Caerphilly County Borough Council
B425 I Gelligroes to Ynysddu
Road Safety Review and Road
Restraint System (RRS) Assessment

**Road Safety Review and Road
Restraint System (RRS) Assessment**

March 2023

Job No:	LTP/23/5353	File Ref:	B4251 Road Safety Review and RRS Assessment - Final Issue 2		
Issue	Revision	Description	Author	Checked	Date
FINAL	Issue 2	Revised final (minor revs)	RP	RP	06/09/2023
FINAL	Issue 1	Final report to Client	RP	NW	30/03/2023
Authorised for Issue:				NW

Figure 2: B4251 Speed Survey Locations

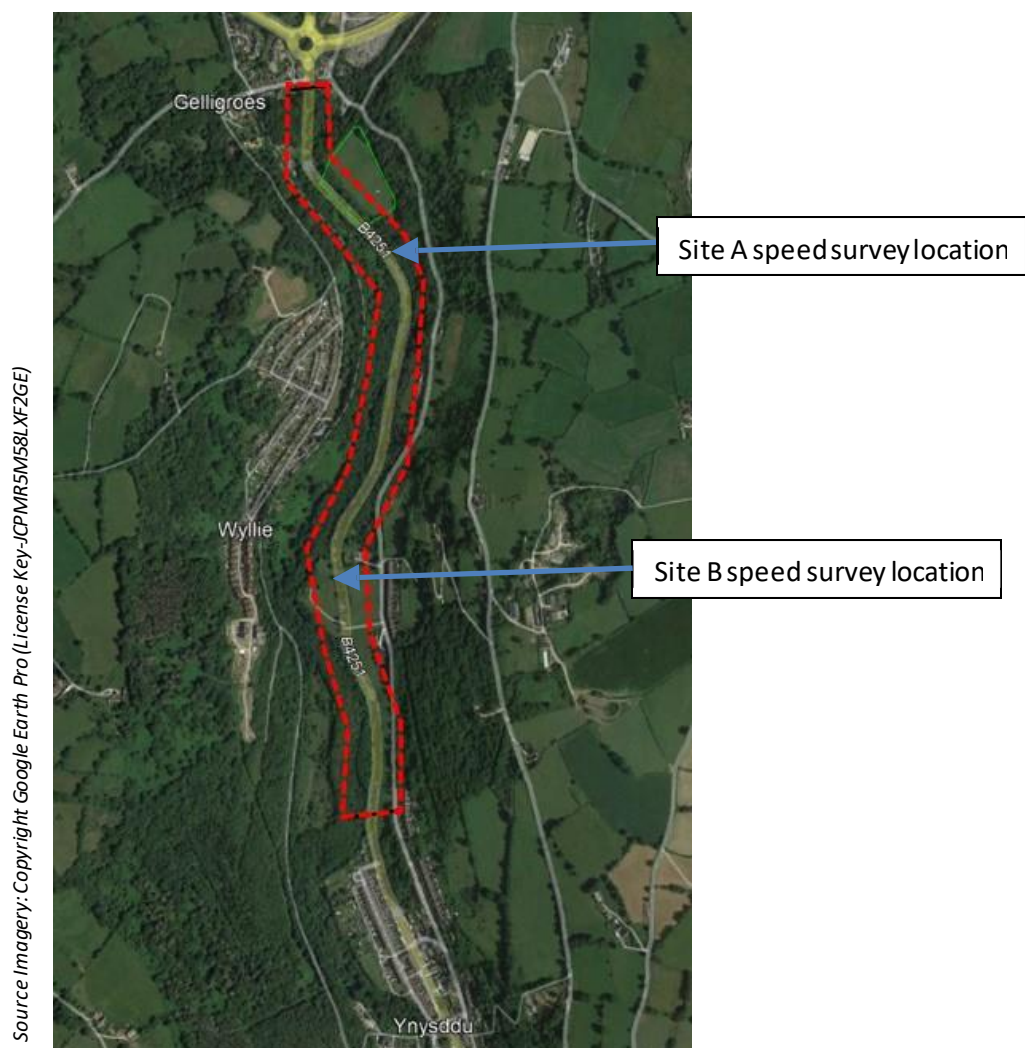
2.2.3 Two-way mean vehicle speeds are 41mph at Site A and 39mph at Site B and are therefore considered generally consistent with the posted 40mph speed limit. Recorded 85th %ile speeds are around 4-5mph higher than mean speeds and this magnitude of difference is in line with what could typically be expected.

2.2.4 'Setting Local Speed Limits in Wales' states that "mean speeds should be used as the basis for determining local speed limits as these reflect what the majority of drivers perceive as an appropriate speed for the road. The aim should be for the mean speed driven on the road to be at or below the posted speed limit" (Welsh Assembly Government, 2009). Based on the recorded speed data, it is considered that the current 40mph speed limit on the route is appropriate.

Figure 3: Bend Radii

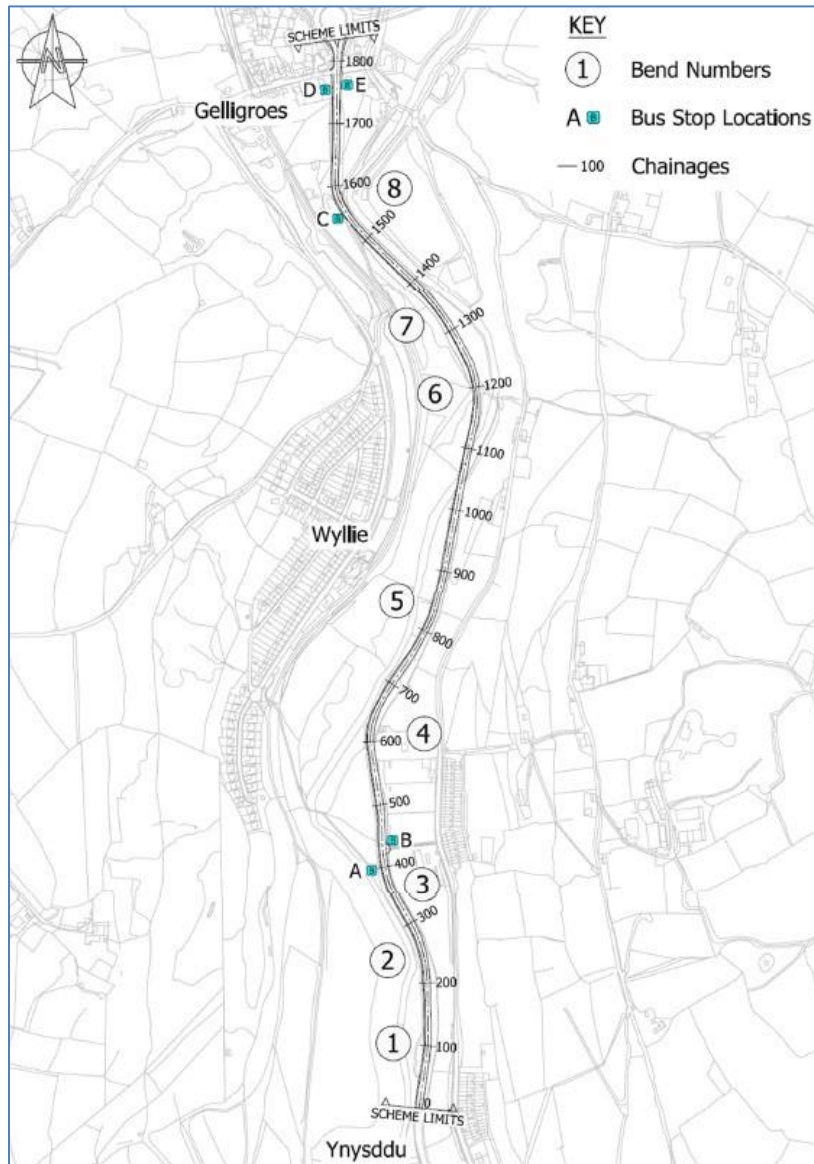
- 3.4.3 The previous assessment with reference to Figure 9.23N2 ‘CD 109 Highway Link Design’ (Highways England, 2020) identified that “the radii should be 510-1020m for a 100kph road (100kph equates to a 60mph national speed limit for this classification of road)” (Amey Consulting, 2020). LTP would not necessarily agree with this as Figure 9.23N2 refers to design speed rather than the posted speed limit. Using Figure 2.1 of the same document, it is considered that the alignment and layout constraints on the route are more akin to a design speed of 85kph (53mph), rather than 100kph (62mph).

- 3.4.4 Regardless of the above, the previous assessment found that radii on all 8 bends fell well below the current standards for the 100kph speed which was used (see Table 11). In commenting on this, the report outlined that *“as the stretch of road within the study area is a well-established route, it is not expected to conform to current standards. Motorists are obligated to take the road as they find it, which means they should drive at an appropriate speed for the conditions. However, motorists may differ significantly in their interpretation of the conditions. This conflict has the potential to cause a hazard to all road users”* (Amey Consulting, 2020).

- 3.4.5 **Bend radii for new roads (current assessment)** – As outlined above, LTP consider the route to have a design speed of 85kph. However, at the same time, recent speed surveys have identified actual vehicle speeds on the route to be lower than this with mean speeds of 39-41mph and 85th %ile speeds of 44-45mph. This is not uncommon and ‘MfS2’ states that designers should *“consider the potential for reducing design speed locally, where it is appropriate that traffic should travel more slowly”* (CIHT, 2010). The next design speed below 85kph in CD 109 is 70kph, which equates to a speed of 43.5mph which is broadly in line with the recorded 85th %ile speeds on the route (44-45mph).

- 3.4.6 The final two columns of Table 11 identify radii requirements for speeds of 85kph (design speed of the route) and 70kph (actual speeds on the route). Aside from at bend 7, the achievable radii at all bends remains below the levels required at speeds of 85kph and 70kph. However, and as per the previous assessment, as a well-established route it is very unlikely that it would meet current DMRB standards. It is considered that the bend radii on the route, although below standards outlined within DMRB, are not significantly different from bends that can be found at other comparable locations in Caerphilly and across Wales. As previously outlined, it is also noted that the application of DMRB standards is not mandatory on roads such as the B4251. The previously discussed collision record also identifies improved road safety performance since the 40mph speed limit covered the full route. In addition, the speed data identifies that the 40mph speed limit appears to be successfully controlling vehicle speeds to around the level of the posted limit which should encourage more appropriate driving speeds at the bends.
